Amberwood Village Recreation Association 54 Springbrook Drive Stittsville (Ottawa), ON, K2S 1B9 November 18th, 2020

RE: 54 Springbrook Drive Combined Environmental Impact Statement & Tree Conservation Report – Addendum #1

MES (2020) was prepared to support the Zoning Bylaw Amendment and Part Lot Control applications for the proposed development (City of Ottawa File #: D02-02-20-0083). First submission review comments were received from the City of Ottawa and the Mississippi Valley Conservation Authority (MVCA) on November 5th, 2020. The purpose of this letter is to provide additional information in order to respond to the first submission review comments. This letter serves as Addendum #1 to the Combined Environmental Impact Statement (EIS) and Tree Conservation Report (TCR) (MES 2020). This letter report is intended to provide supplemental information that expands upon the Combined EIS and TCR (MES 2020). This letter report is intended to be read in conjunction with MES (2020). For

FIGURE 1: SITE OVERVIEW

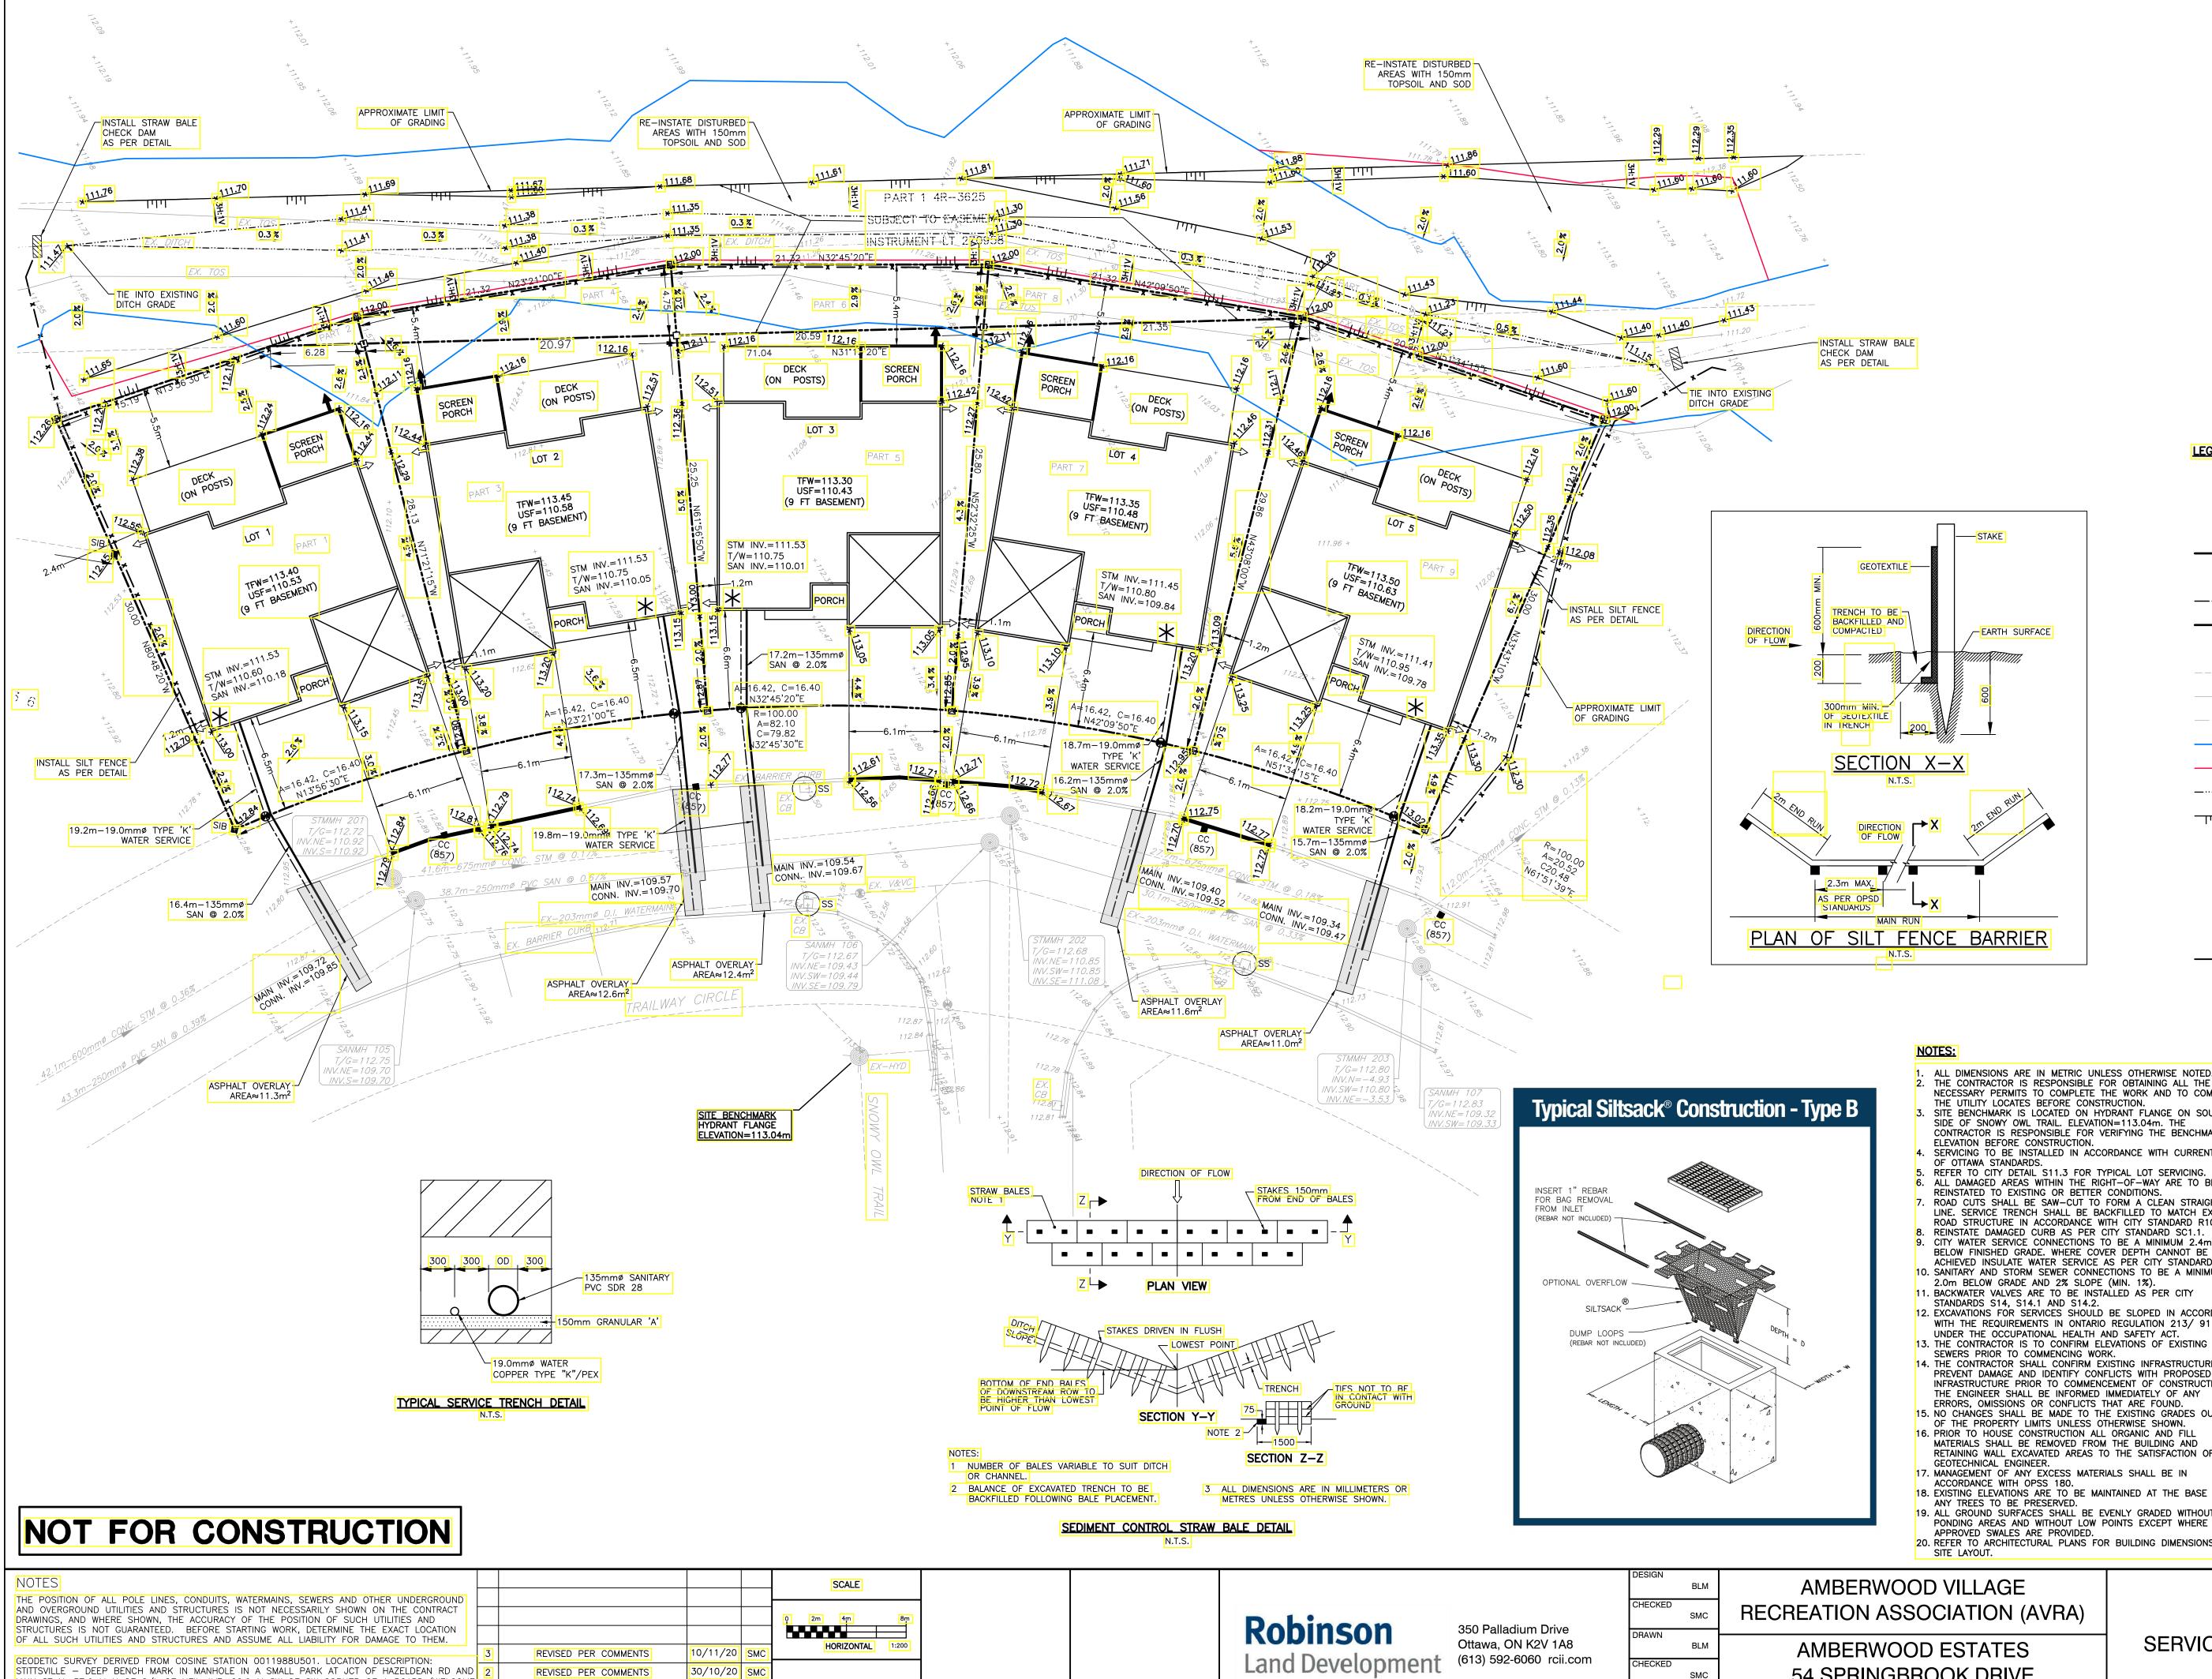
Several comments from the City of Ottawa requested further information regarding the potential retention of trees within the Site. As described in Section 4.1 of the Combined Environmental Impact Statement (EIS) and Tree Conservation Report (TCR), all trees within the proposed development area will be removed in order to accommodate the construction of the five (5) new single detached homes. The density of the proposed development, as well as the anticipated extent of excavation and grading works, is such that it is not feasible to retain trees within the development area (MES 2020). However, opportunities to retain trees around the Site edges and within adjacent properties have been identified. The potential to retain trees along the Site edges and within adjacent properties is summarized below:

SERVICING AND GRADING PLAN

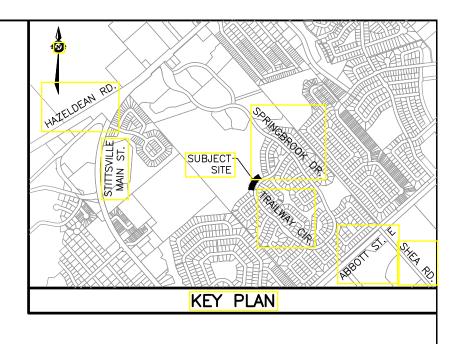
- Southwest Boundary: An existing residential home (1 Pine Bluff Trail) is located along the southwest edge of the Site. As shown in the Servicing and Grading Plan (included below), a side-yard setback that varies between 1.2 m and 2.4 m wide will be maintained adjacent to 1 Pine Bluff Trail. The Site grading will match existing grades adjacent to 1 Pine Bluff Trail. This is anticipated to be sufficient to retain the trees found on the adjacent property (1 Pine Bluff Trail). Within the Site, trees will be retained within the side-yard setback, wherever feasible and compatible with the development and grading requirements.

- Northeast Boundary: A sewer easement is located adjacent to the northeast boundary of the Site. As shown in the Servicing and Grading Plan (included below), a side-yard setback that varies between 1.2 m and 2.4 m wide will be maintained adjacent to the sewer easement. The Site grading will slope downwards along the northeast boundary of the Site to match existing grades within the sewer easement (just beyond the Site boundary). This is anticipated to be sufficient to retain the majority of trees found northeast of the Site within the sewer easement. Within the Site, trees will be retained within the side-yard setback, wherever feasible and compatible with the development and grading requirements.
